Attachment E

Submissions

Subject: FW: Submission - D/2025/385 - 18-28 Briggs Street CAMPERDOWN NSW 2050- Attention Max Di Rosario

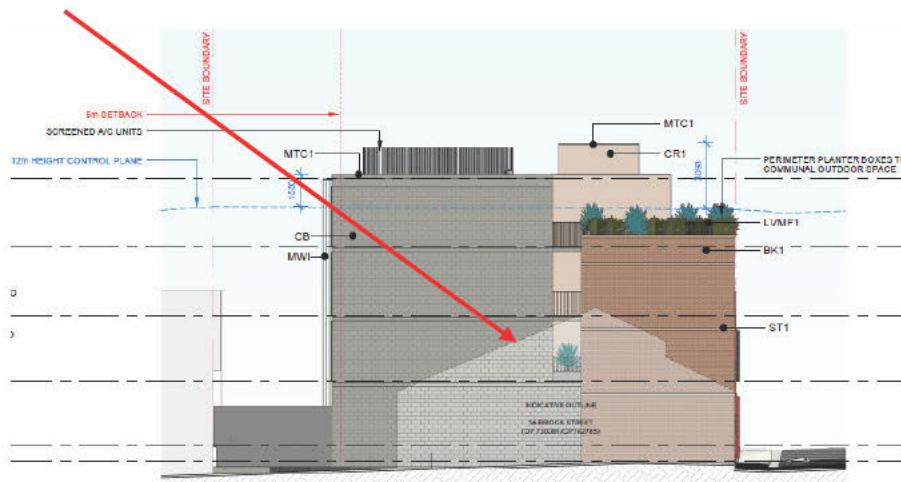
- **Height, length, and insufficient articulation detract from heritage character:** The Plans (p17) depict the streetscape opposite the proposed building (shown below). The bulk of the proposed building, and its position relative to the heritage items, is the shaded blue box. It looms over the heritage items (shown numbered, though missing 3 more at #31, 33, and 35):

ELEVATION 2 - 9AM - BRIGGS ST

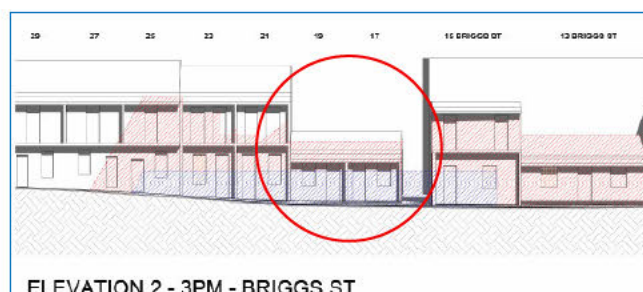
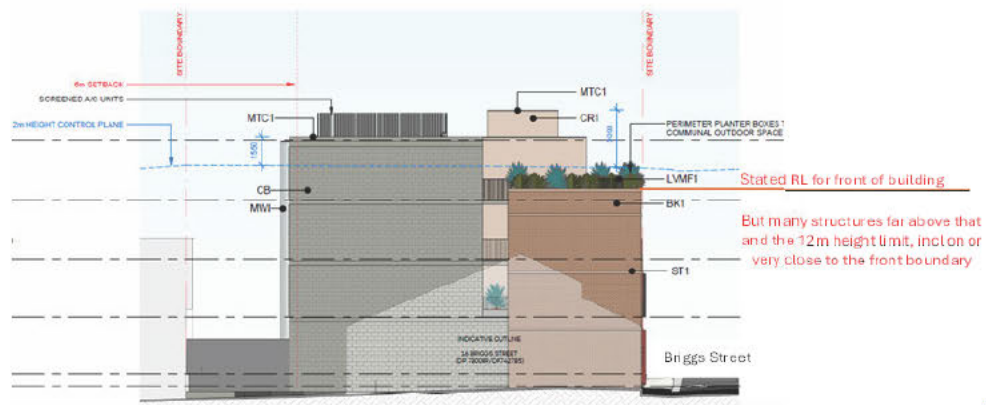
- **Approval would assure less than 2 hours direct sunlight to habitable rooms:** While I believe my tiny heritage-listed home at #19, and my neighbour's at #17, already get less than 3 hours of direct sunlight in winter, this situation will be further worsened by the proposal, which would assuredly result in less than 2 hours. Each of these two houses has only one window and door facing north (onto Briggs Street). The increased overshadowing from the replacement of a 2-storey building with one at 4-storeys is significant given the existing lack of sunlight. Shadow diagrams show total darkness to

both homes' north-facing windows and doors at 9am and 3pm, and the window at my home (#19) getting sun to about half of it at 12pm, while that at #17 never gets any sun at times displayed. I thus fear that direct solar access will be virtually eliminated (and far less than 2 hours) if the new building is approved as designed.

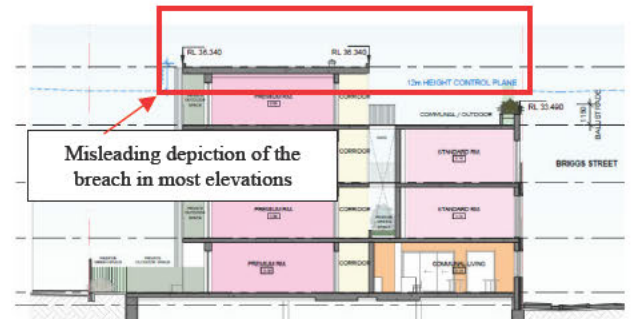
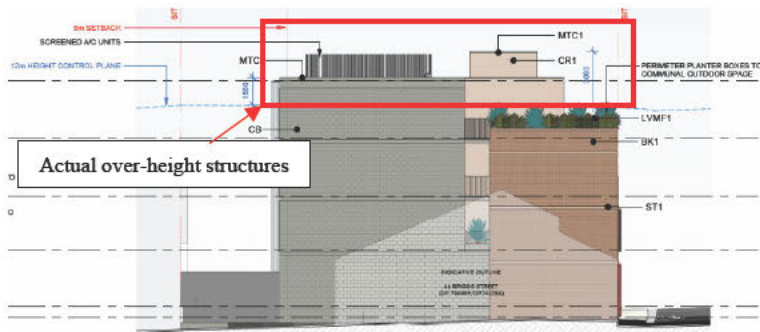
- **Elevations are misleading for actual building height** (p12-13 Architectural Plans, and p 5 Request for Variation): Elevations are depicted missing elements that surpass height limits (e.g. the entire 4th floor, AC and screening, stair wells, and lift well), giving the misleading impression that the breach and overheight aspects of the design are far more minimal than they actually are:

- o p13: North-south section 1 missing AC and screening, stair wells, lift well
 - o p13: North-south section 2 missing AC and screening
 - o p13: East-west section 2 missing the whole 4th floor, AC and screening

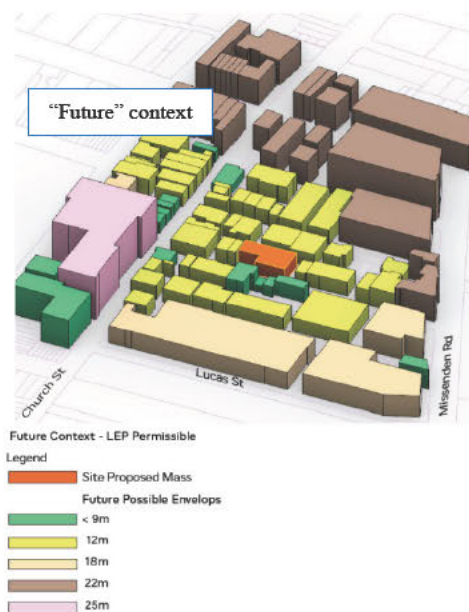
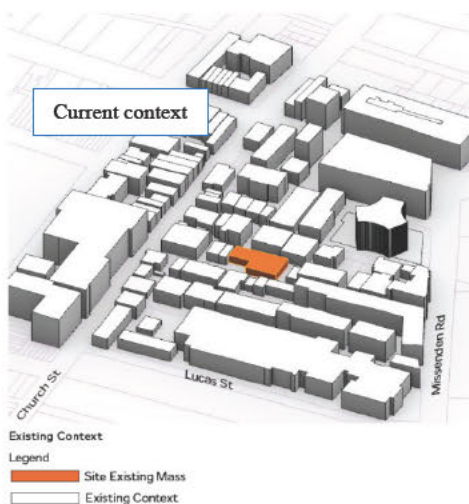
- **Co-Living Report graphic is misleading for height** (p30): Erroneously shows the lift and stair wells, which tower over the street at up to 14.84m high with a setback of only 3m, as the same height as the 3-storey front part of the building that conforms to the 12m height limit, despite being more than a full storey above it. (Also missing the 4th floor and AC screening). The development will thus not look anything like this in terms of bulk, height, or scale.

Main Entrance from Briggs St

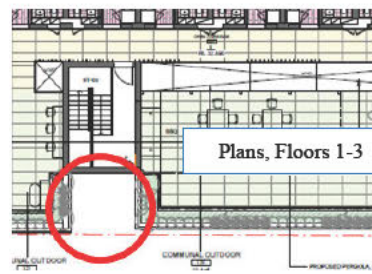
- **The building articulation depicted is misleading:** Throughout the documents (Plans, SEE, Co-Living Report, etc) the graphic shows the required full-height, complete break in the façade to visually present 2 buildings, when in fact it is only a doorway setback of approx 3m deep by 3m wide. The gate at ground floor level (set back less than 1m) is hidden in shadow.
